00436440, 00674704, 00703146

EN Replacing 00436440 Nexxt and 00674704 / 00703146 Vision drain pumps

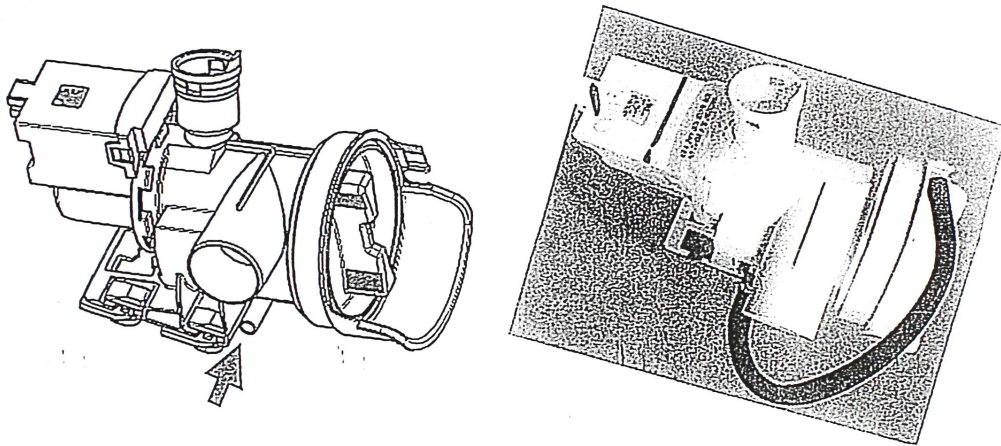
Due to a vendor change, 00436440 Nexxt drain pumps are provided differently. Original housings aren't available, replaced by newer housings with open manual drain hose ports, instead of plugged (see drawing below for port location). To avoid leaking, replacement 00436440 drain pumps come assembled with manual drain hoses (with hose clamps and plugs) since production washers didn't include hoses. Hoses must be stowed near drain pumps when installed.

00703146 drain pumps are no longer available and are replaced by 00436440 drain pumps. Drain hoses provided with 00436440 drain pumps are too short (for WFVC UC/26 and up 4-shock Vision washers) and must be replaced with existing washer drain hoses.

Hoses are the same as supplied with WFVC UC/19 – UC/25 Vision washers, so 00436440 drain pumps can replace 00674704 drain pumps as is.

To avoid leaking on WFMC/WFXD Nexxt washers, do not remove hoses, hose clamps or plugs from pumps.
